October 18, 1984

DOCKET NUMBER 50-483
CALLAWAY PLANT, UNIT 1
TECHNICAL SPECIFICATION AFFIRMATION AND PROPOSED FSAR CHANGES

In addition, the attached pages represent differences between the as-built plant and the FSAR. These will be included in the next revision to the FSAR.

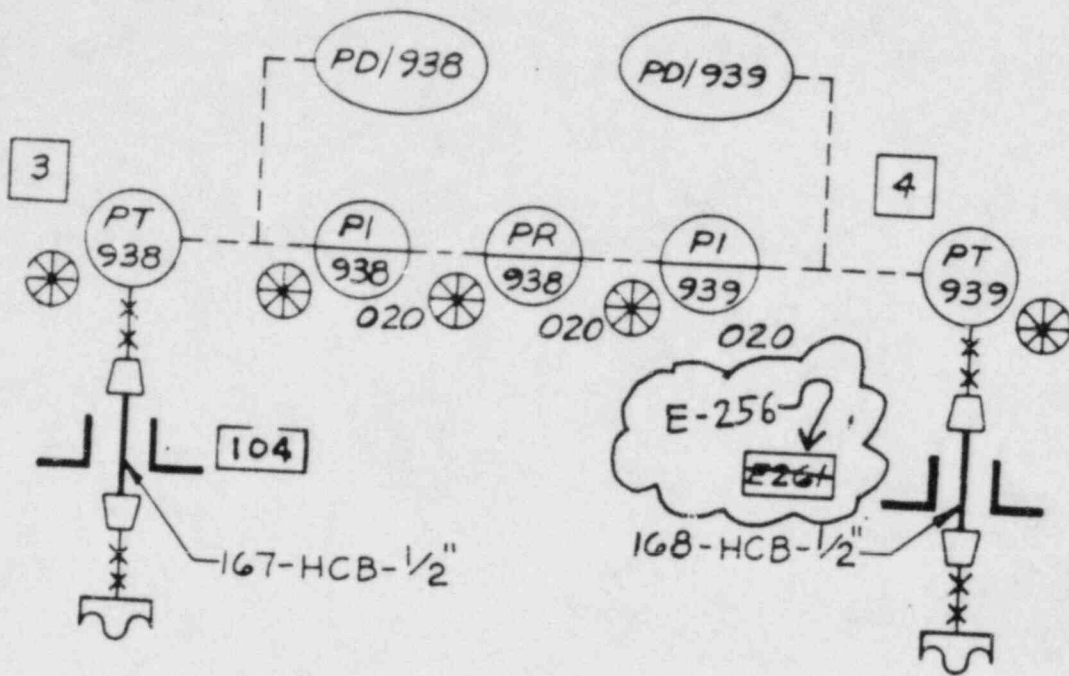
EMERGENCY OPERATION - ^{downstream} Located in the control building supply system ductwork, ~~upstream~~ of the supply unit, are redundant radiation monitors, ~~redundant chlorine monitors~~, and a smoke detector. These monitors sense contaminants in the influent and alarm in the control room when limits are exceeded. The high radiation and chlorine monitors (chlorine concentrations of 5.0 ppm or greater) initiate isolation of the control building normal supply and exhaust systems. The chlorine monitors comply with the requirements of Regulatory Guide 1.78, as discussed in Table 6.4-1. Chlorine monitors are not required for the Callaway plant per Section 2.2.3.1.3 of the Callaway Site Addendum.

CONTAINMENT PENETRATIONS
 FIGURE 6.2.4-1
 PAGE 72 OF 74

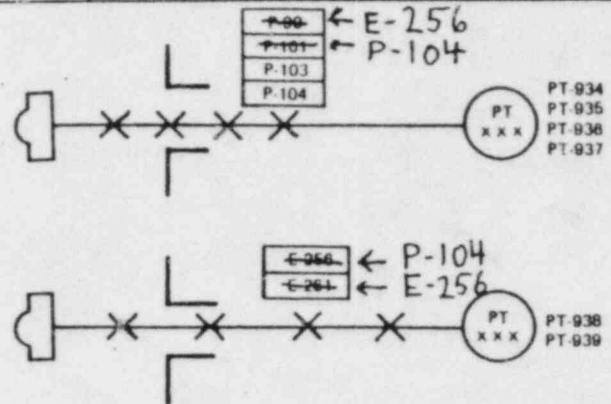
GENERAL COMMENTS:
 PT 934, 935, 936 AND 937
 THERE ARE FOUR INSTRUMENT LINES WHICH PENETRATE THE CONTAINMENT AND WHICH ARE REQUIRED TO REMAIN FUNCTIONAL FOLLOWING A LOCA OR STEAM BREAK. THESE LINES SENSE THE PRESSURE OF CONTAINMENT ATMOSPHERE ON THE INSIDE AND ARE CONNECTED TO PRESSURE TRANSMITTERS ON THE OUTSIDE. SIGNALS FROM THESE TRANSMITTERS CAN INITIATE SAFETY INJECTION AND CONTAINMENT ISOLATION ON HIGH CONTAINMENT PRESSURE. THEY ALSO, UPON HI-HI CONTAINMENT PRESSURE, PRODUCE THE ONLY SIGNAL TO INITIATE CONTAINMENT SPRAY. IN VIEW OF THIS FUNCTION, IT IS ESSENTIAL THAT THE LINES REMAIN OPEN AND NOT BE ISOLATED FOLLOWING AN ACCIDENT. BASED ON THIS REQUIREMENT, A SEALED SENSING LINE, AS DESCRIBED BELOW, IS USED.

PT 938 AND PT 939 ARE THE WIDE RANGE CONTAINMENT PRESSURE TRANSMITTERS REQUIRED BY NUREG-0737 AND REGULATORY GUIDE 1.87.
